ITEM 1 – Tide View Heights No. 2.

KPB File No.	2021-088
Plat Committee Meeting:	July 12, 2021

STAFF REPORT - ADDENDUM

AMBARIAN PROPERTY

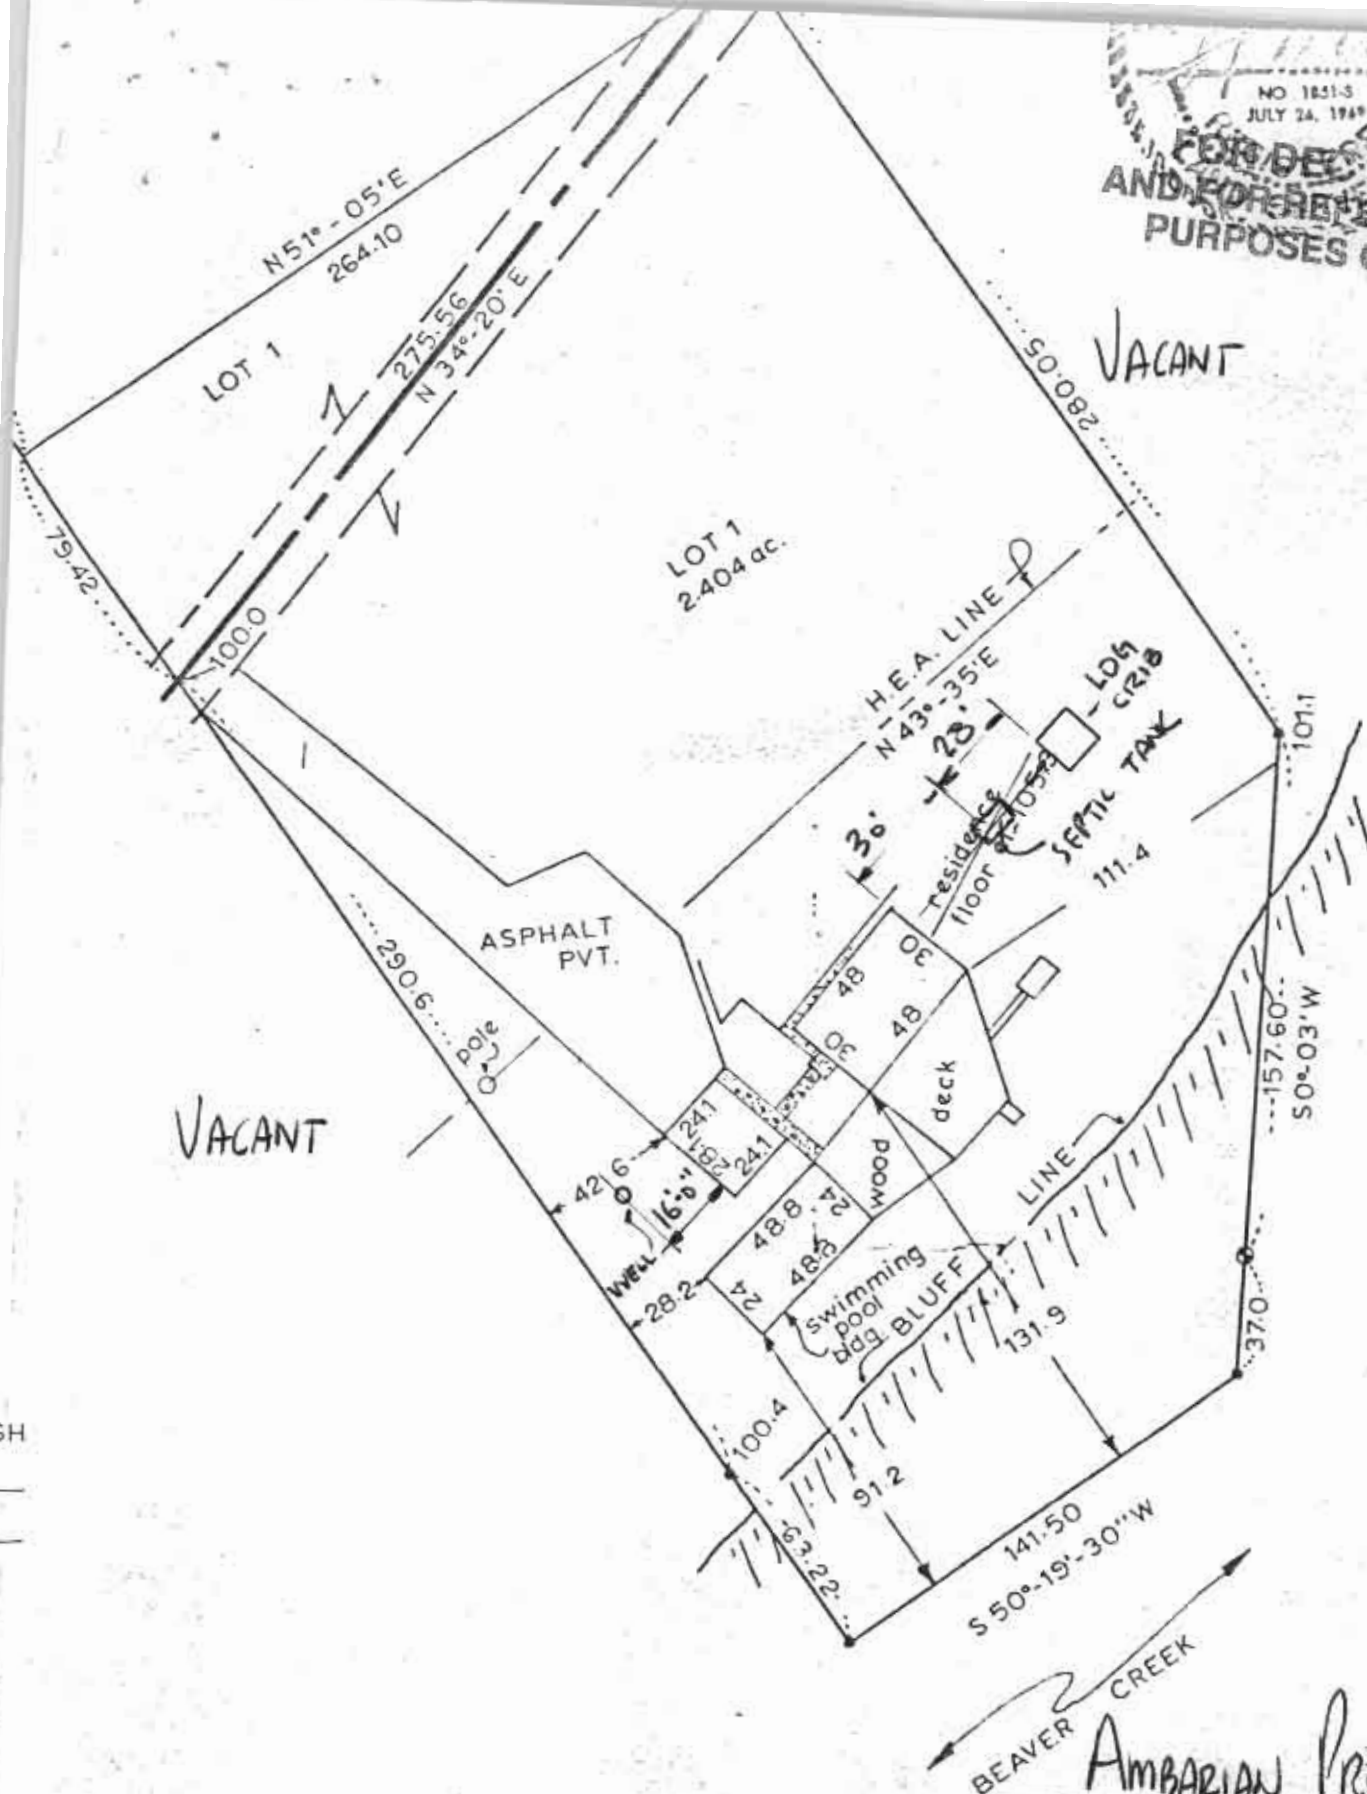
The asbuilt showing the improvements depicts a septic tank and a log crib leach field located to the northeast of the building. The asbuilt shows the log crib to be located more than 58 feet to the northeast from the building. Staff was not able to determine if a new system has been installed since 1980. It appears that the new lot line may encroach on the log crib septic system as shown on the asbuilt survey from 1980.

DEC requires wastewater systems to be at least 50 feet from slopes greater than 25%.

Staff reviewed the exception request and does not recommend approval based on findings 4, 5, 8, 9, 10, 11.
